Informal document No. GRB-50-06  
(50th GRB, 1 – 3 September, 2009, agenda item 3.c)

# NL Proposal for Amending Reg 51-3 Annex 3

issued by the Netherlands  
GRB 50; September 2009

ref: ECE/TRANS/WP.29/GRB/2009/4

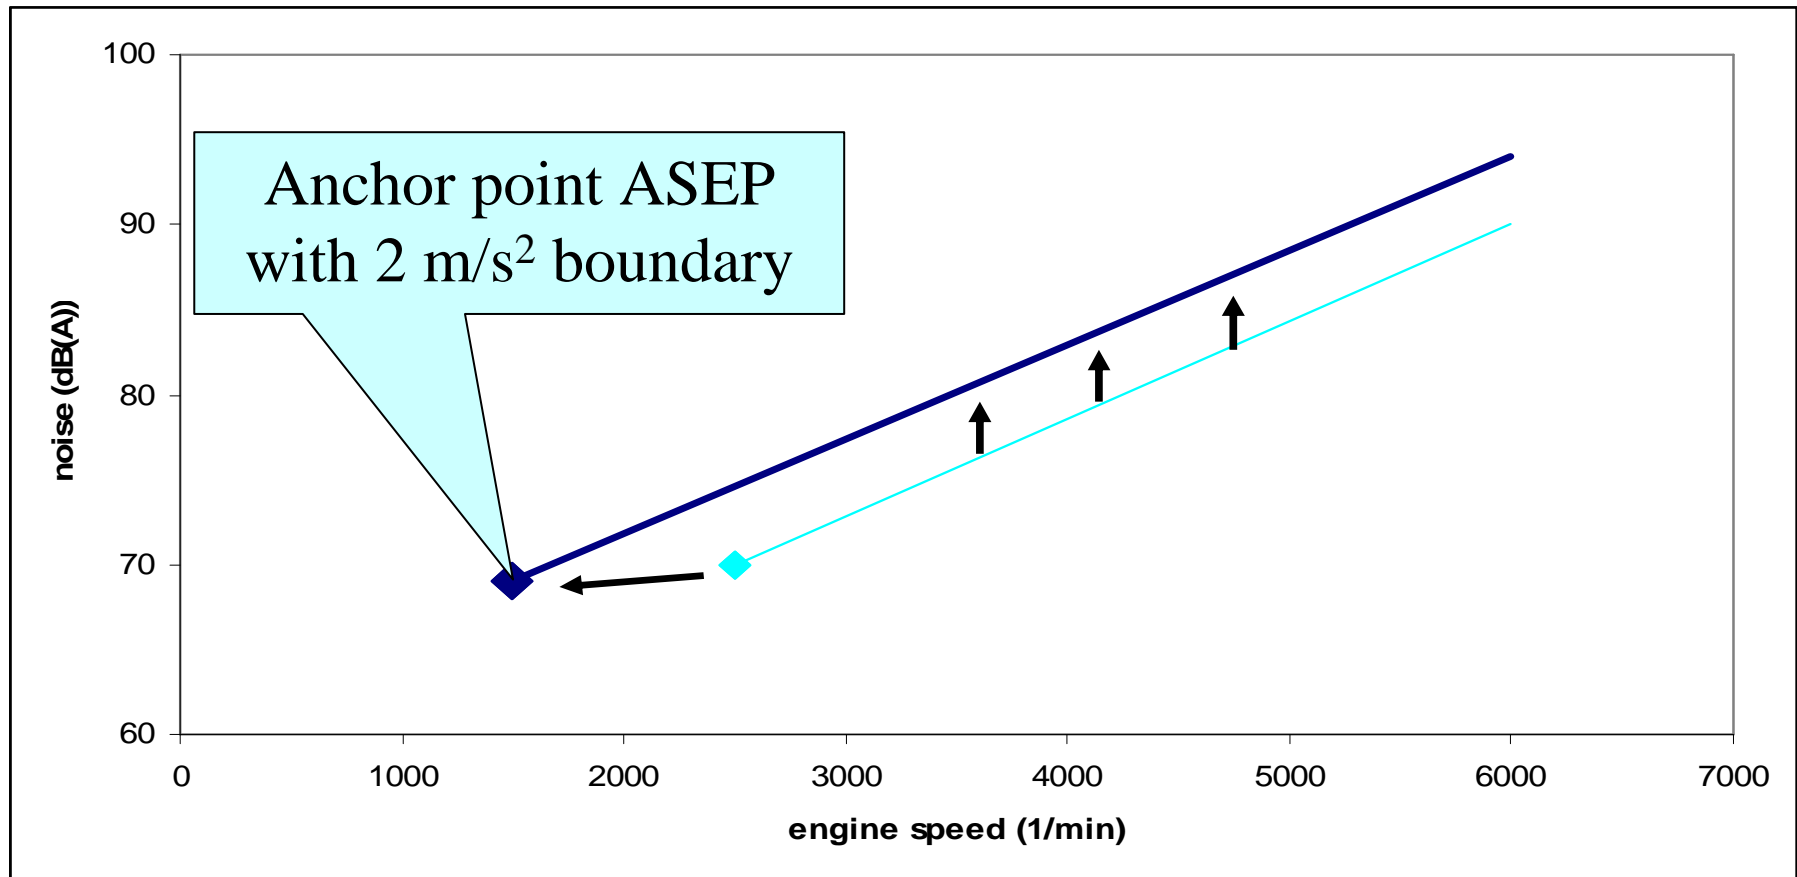
2 m/s<sup>2</sup> boundary forces vehicles to higher gears and so to low(-er) revs in the Annex 3 test situation.

Test result Annex 3 is anchor point for ASEP (revs, Lwot).  
Anchor point ASEP not in balance in the middle of the map, but in the low rev area.

'Higher area' bigger → prediction less accurate

Prediction less accurate → ASEP less accurate

## Boundary of 2 m/s<sup>2</sup> forces the ASEP limit line to the left

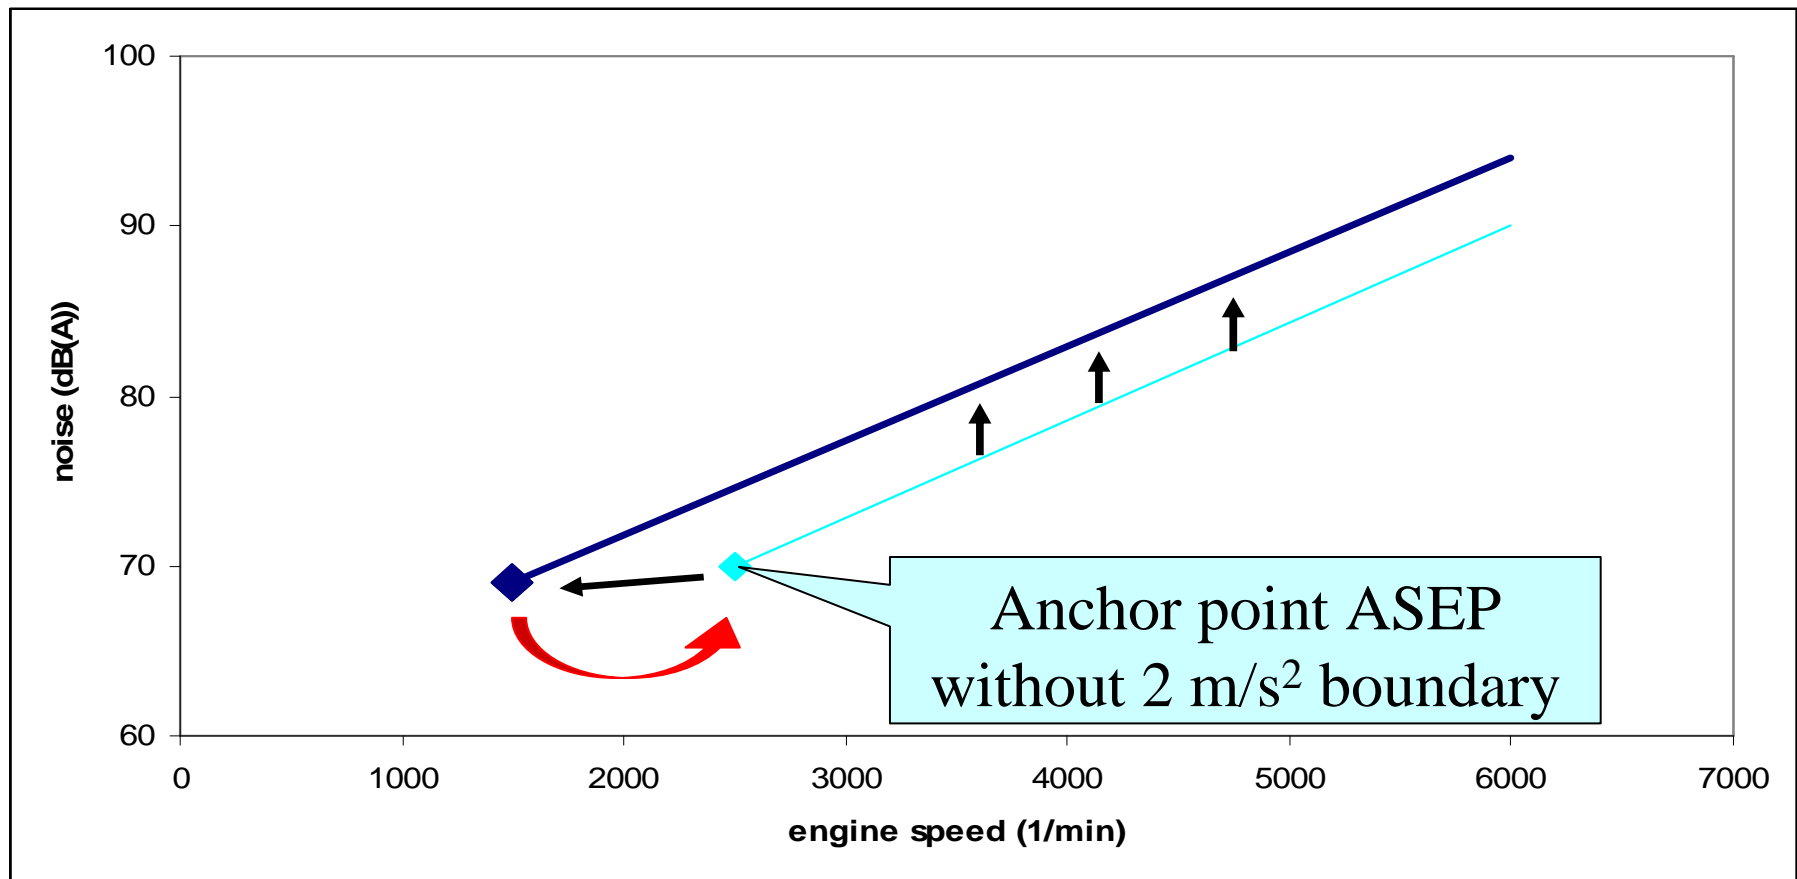
Intention of this proposal:  
go back to the original anchor point (as based on urban statistics)
